**EAST HARTFORD-GLASTONBURY
ELEMENTARY MAGNET SCHOOL PHASE 2
GLASTONBURY, CONNECTICUT
STATE PROJECT NOS. 054-0095 MAG/N/PS & 054-0096 MAG/N/PS
GLASTONBURY BID NO. GL-2011-04**

The following changes to the Drawings and Project Manual shall become a part of the Contract Documents superseding previously issued Drawings and Specifications to the extent modified by this Addendum No. 5. Bidders shall ensure this addendum is acknowledged in the appropriate space provided on the Bid Form when submitting their bid.

DATE: JULY 1, 2010
SCALE: 1/8" = 1'-0"
PROJECT NUMBER: H090230
DRAWING: SK-E701.3

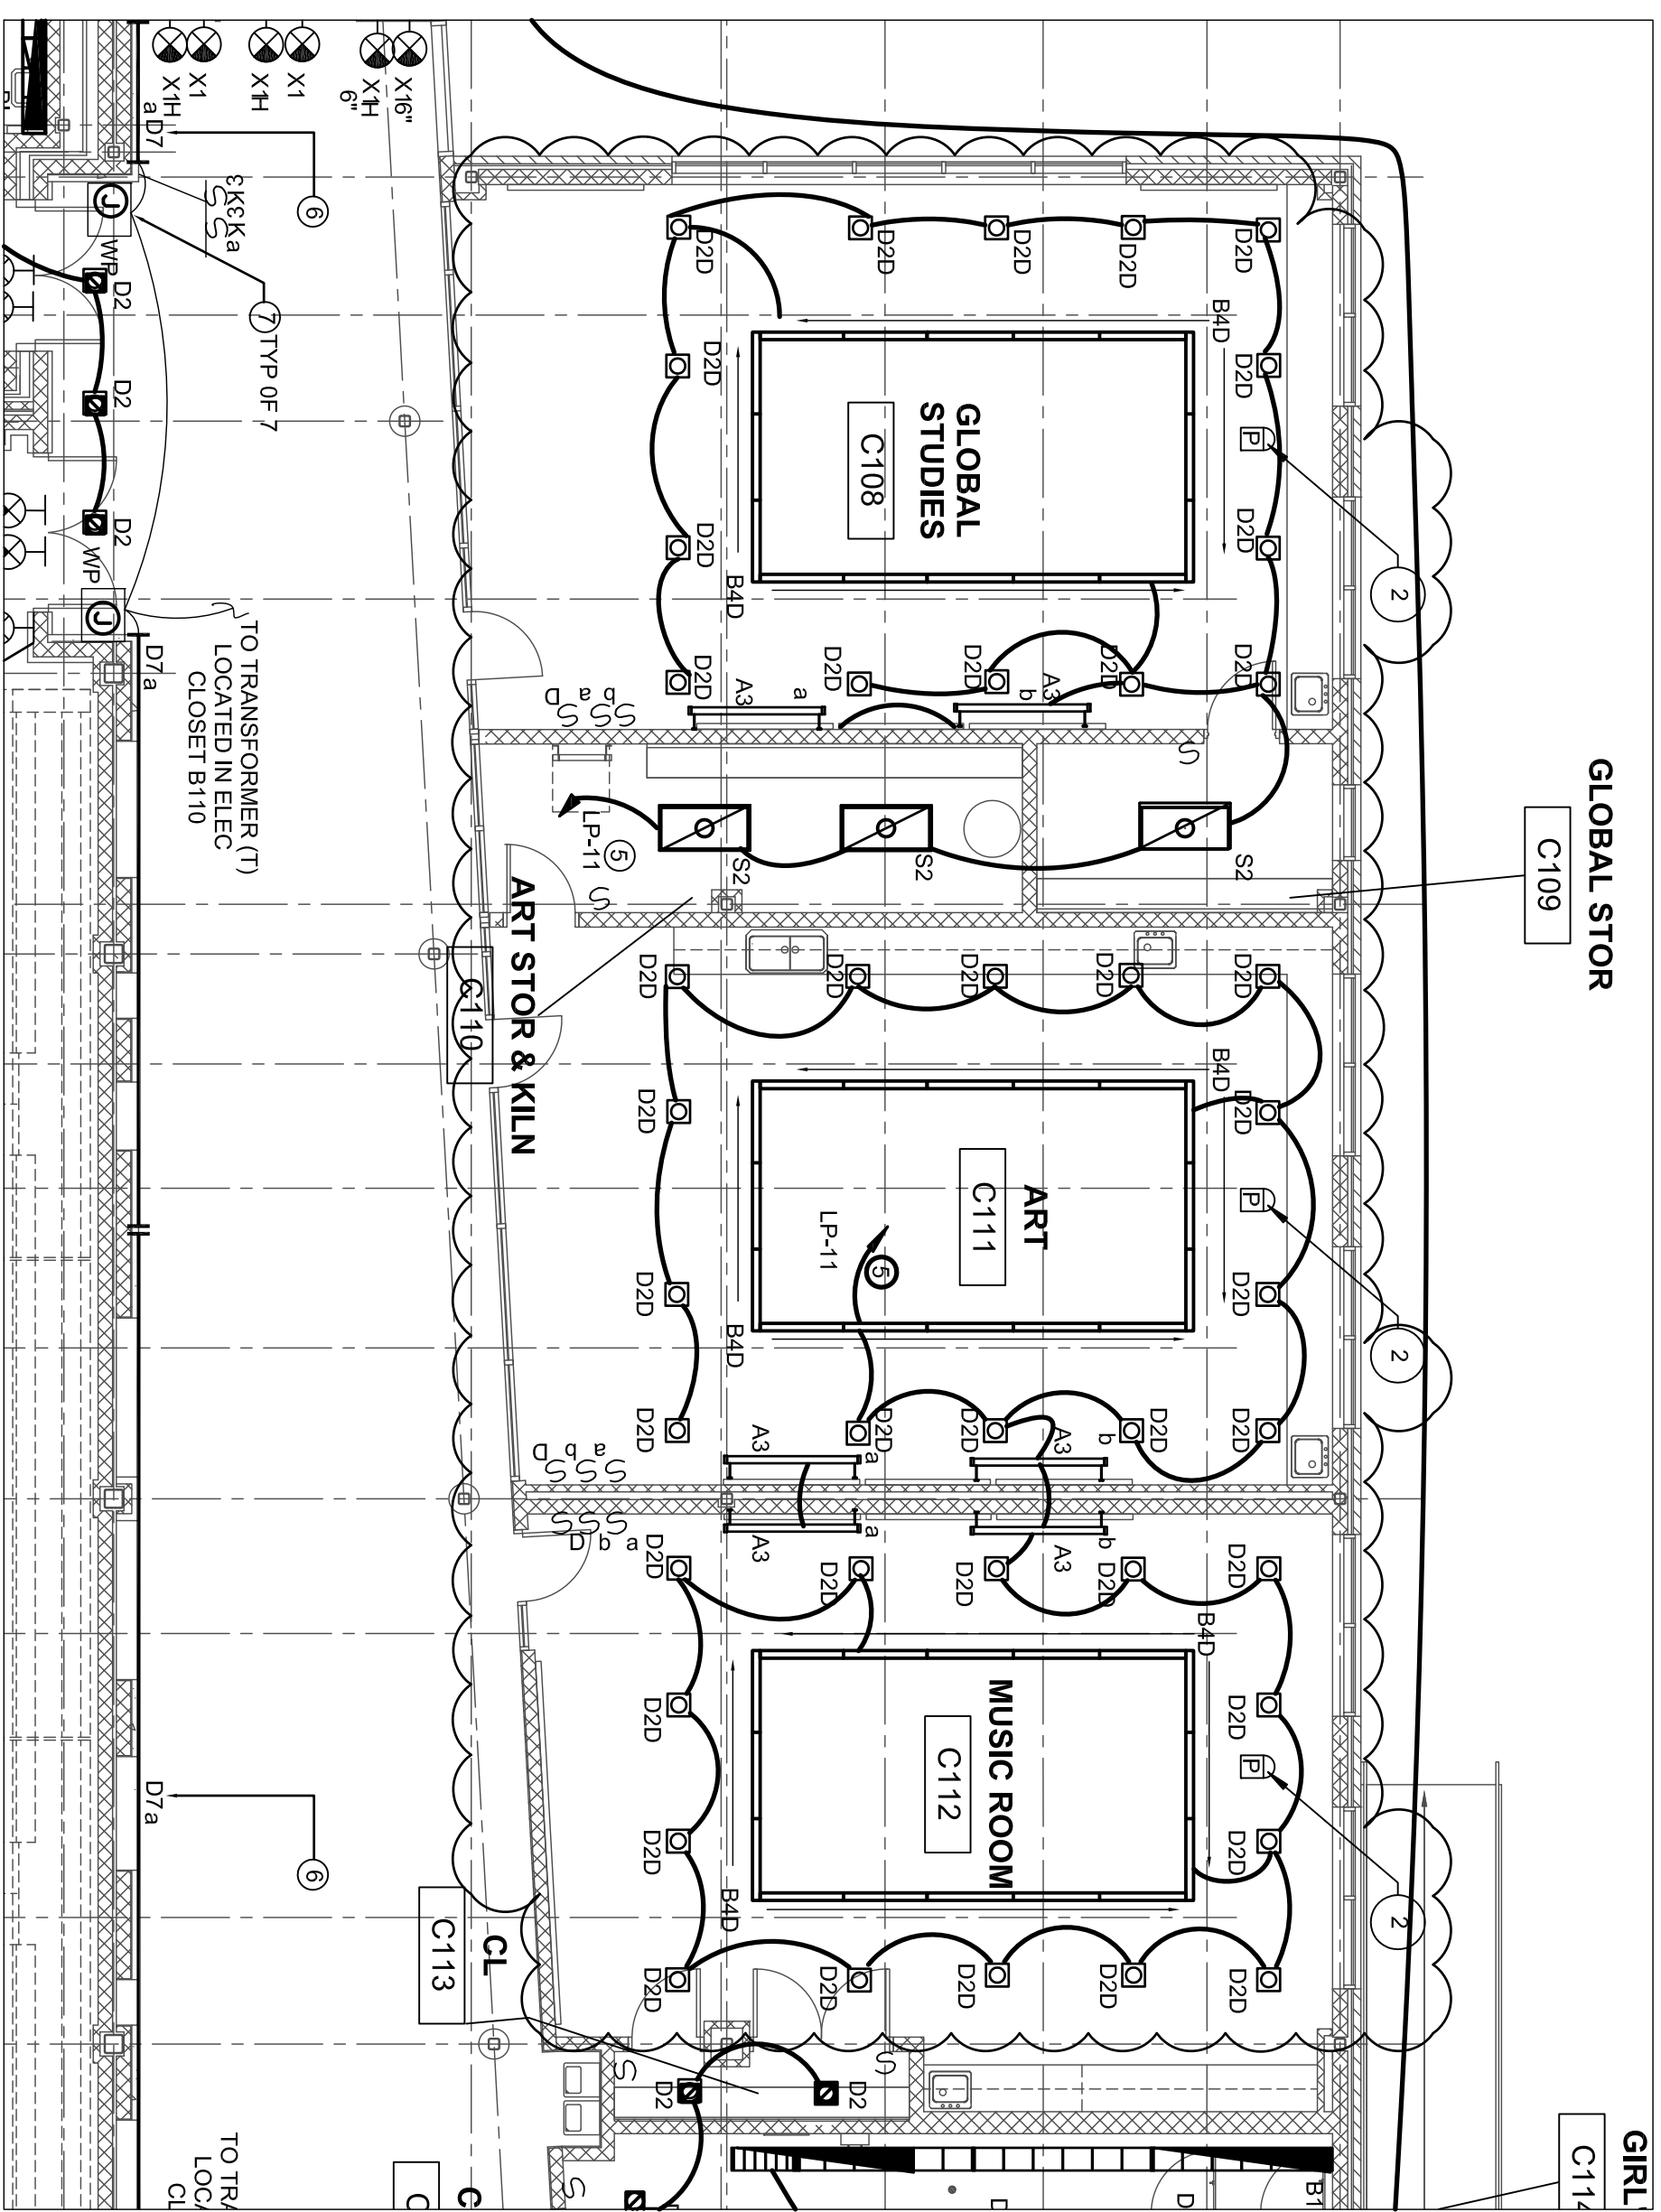
- 1) REVISE Science, Arts and Music room light fixture tags as indicated on Sketch SK-E-701.3 dated 2/21/11 (copy attached).

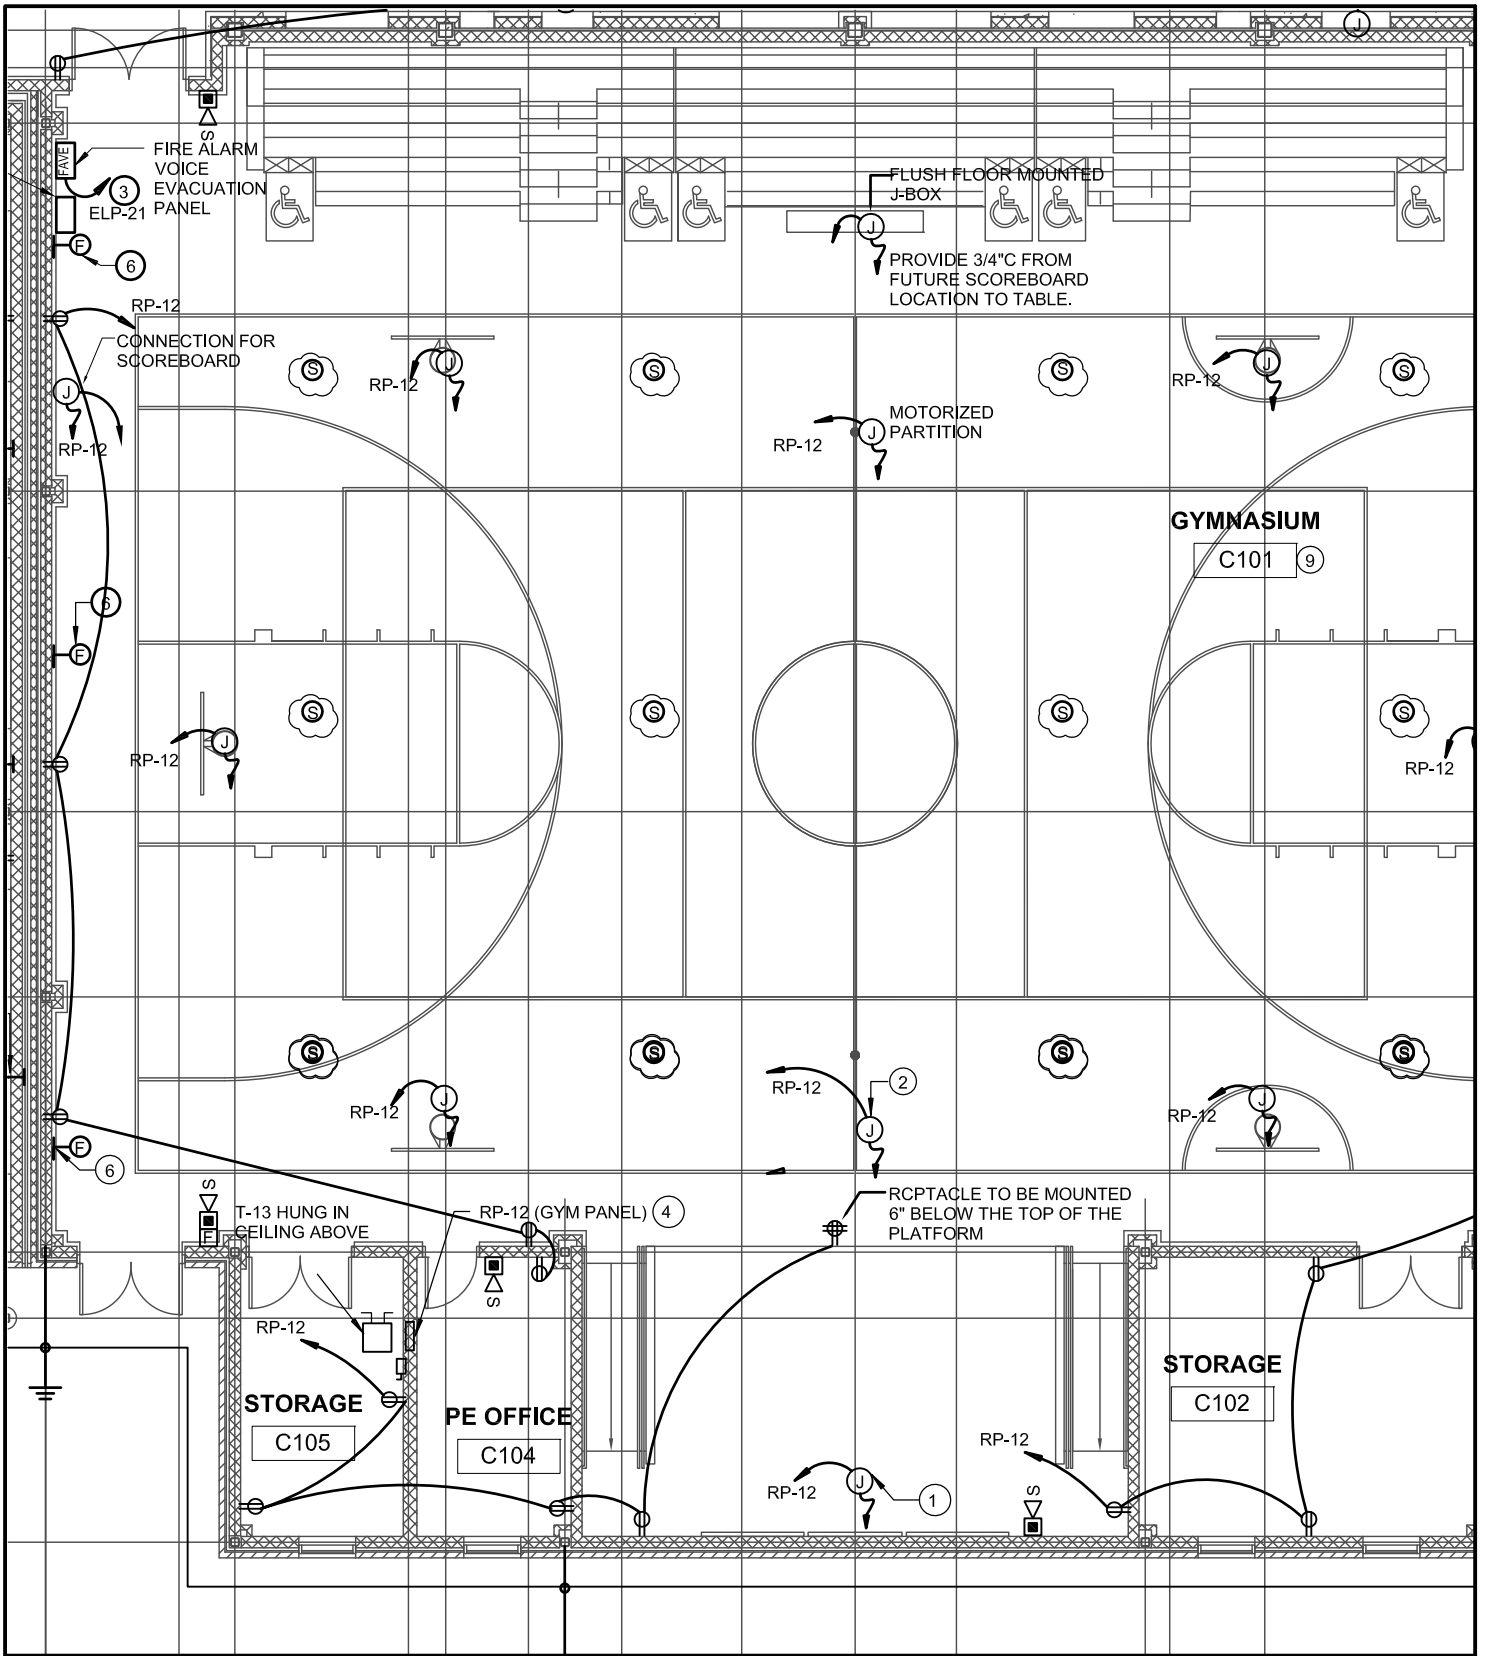
- 2) ADD PA speakers in Gymnasium/C101 as indicated on Sketch SK-E-101.2-2 dated 2/21/11 (copy attached).
- M. DRAWING NO. E-110 – ELECTRICAL ROOF PLAN:

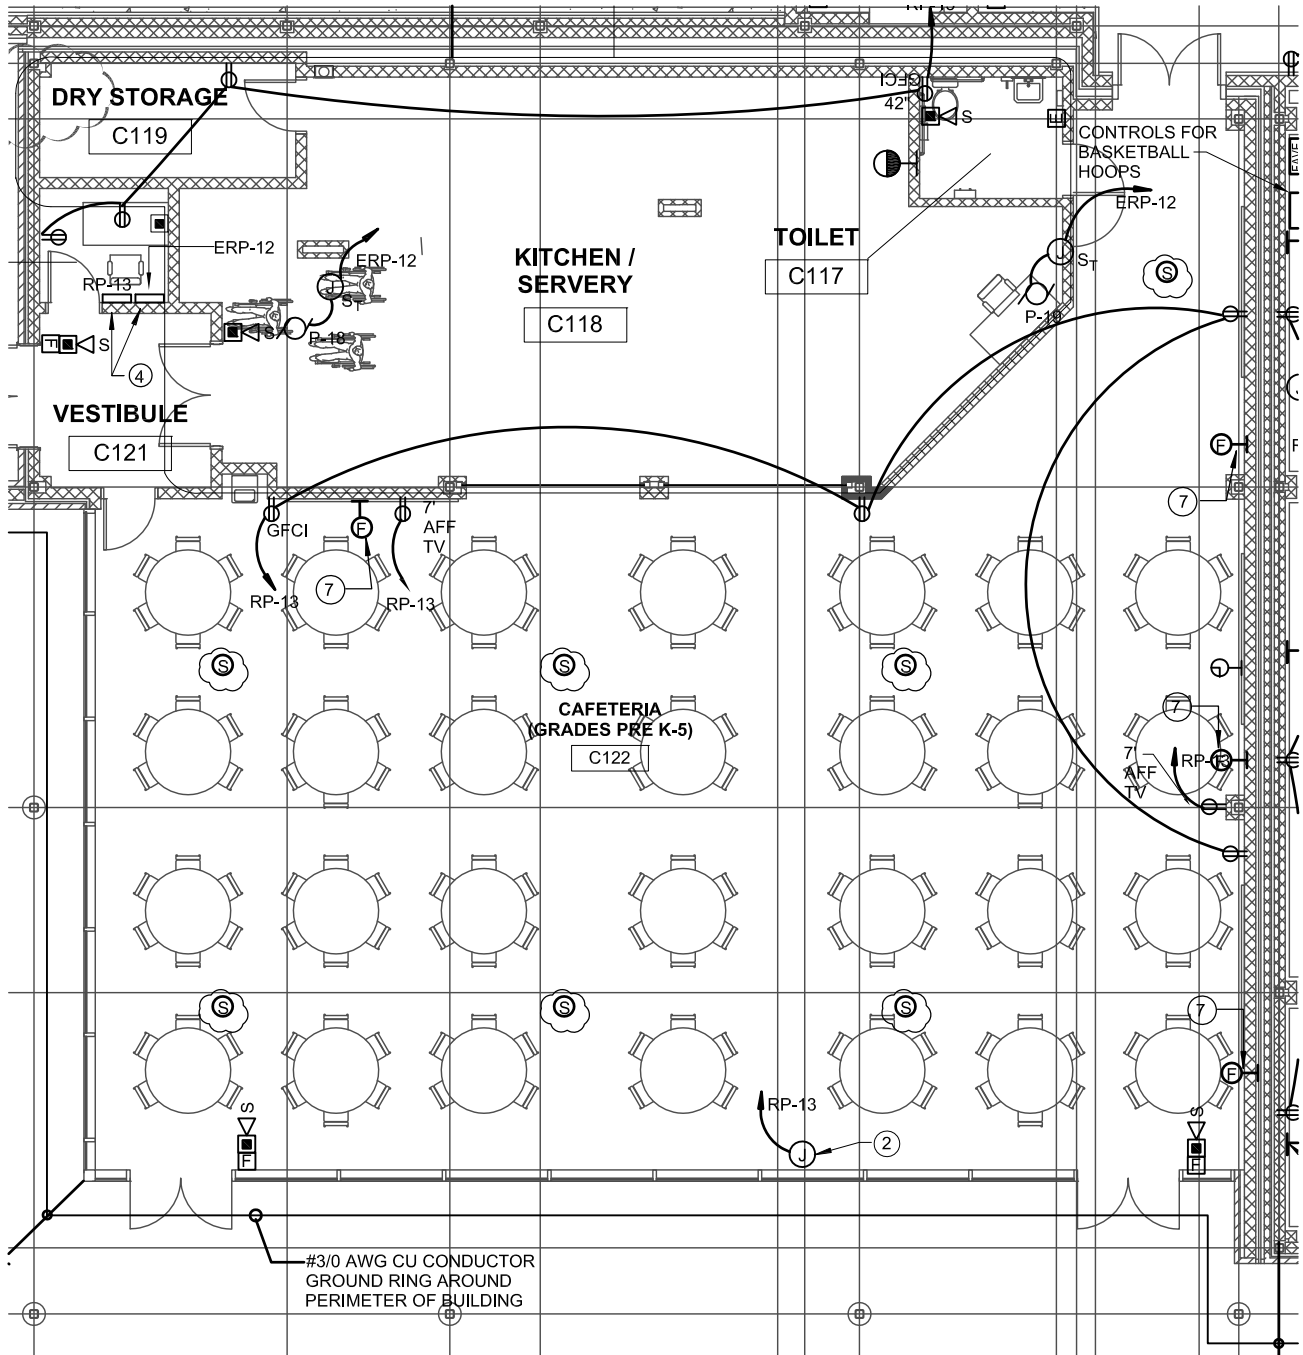
- L. DRAWING NO. E-101.3 – FIRST FLOOR POWER PLAN:
- 1) ADD PA speakers in Cafeteria/C122 as indicated on Sketch SK-E-101.2-1 dated 2/21/11 (copy attached).

SHEET A101.2

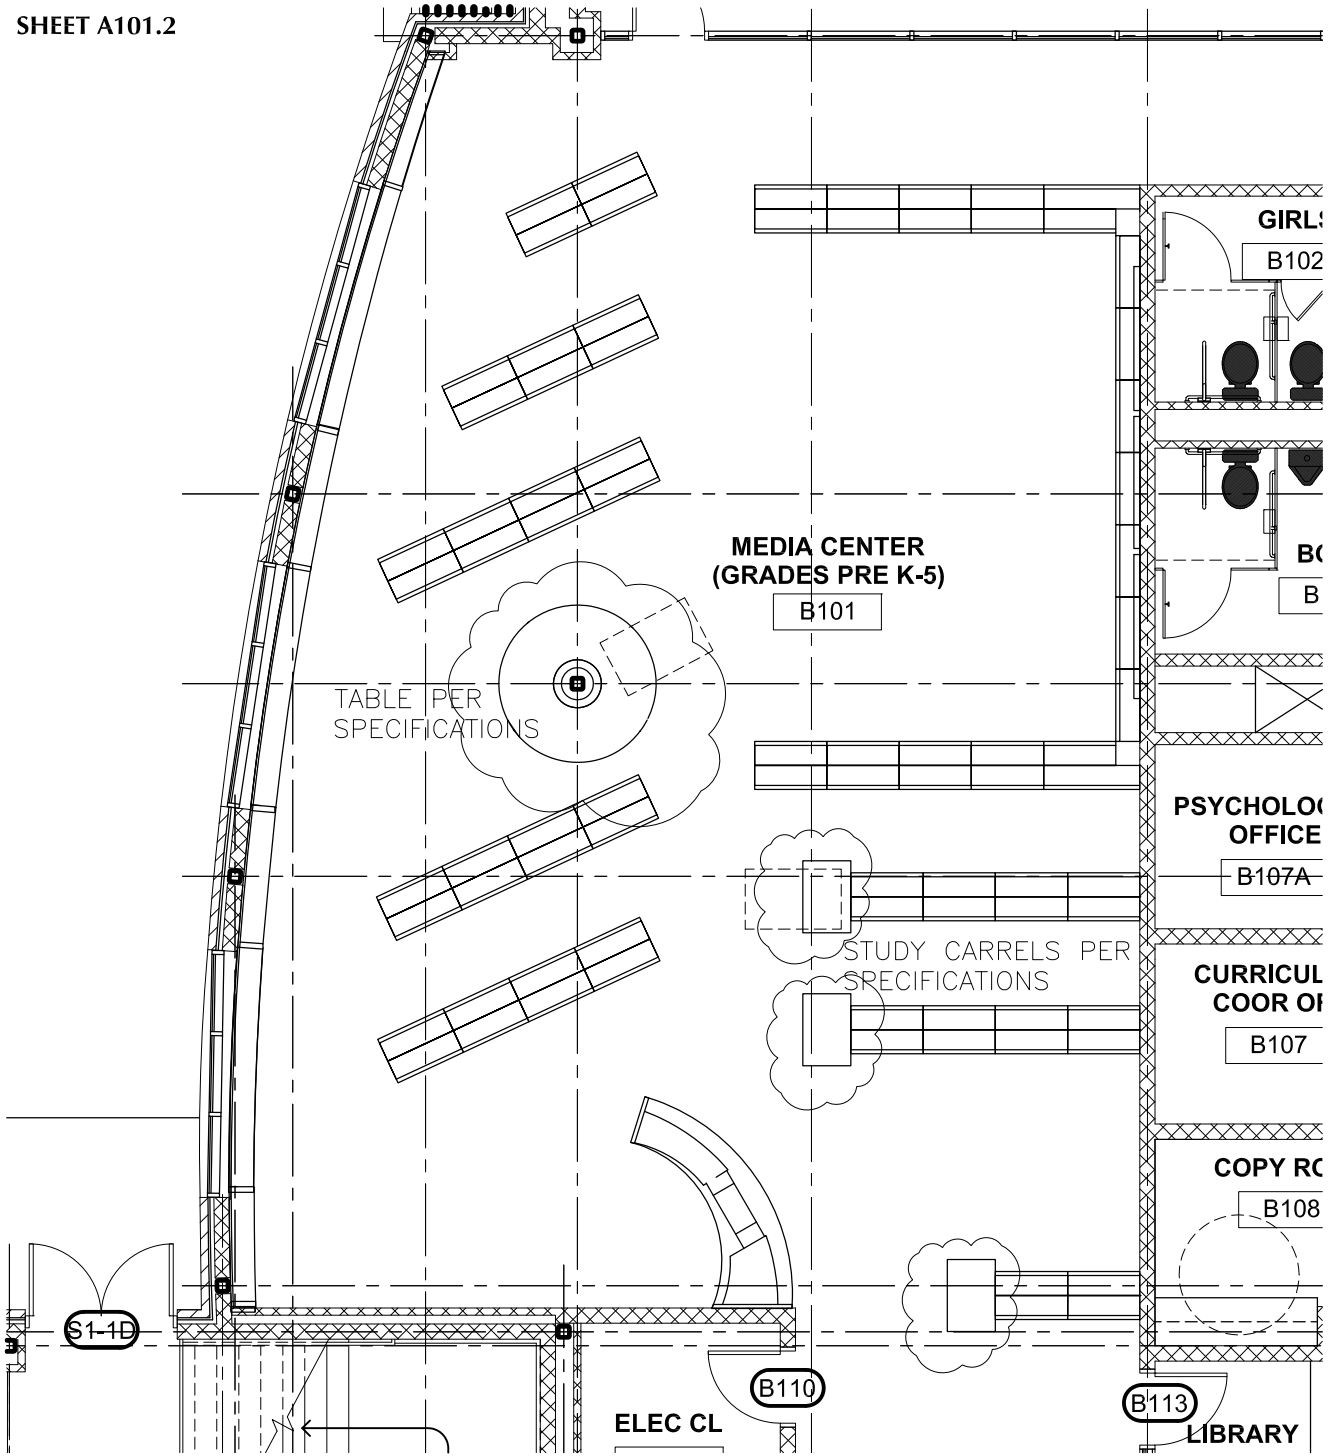
- 1) On First Floor Plan-Part B, in Media Center/B101, ADD indication of table and study carrels as shown on Partial Floor Plan Sketch SK-101.2 (copy attached) dated 2/10/11.
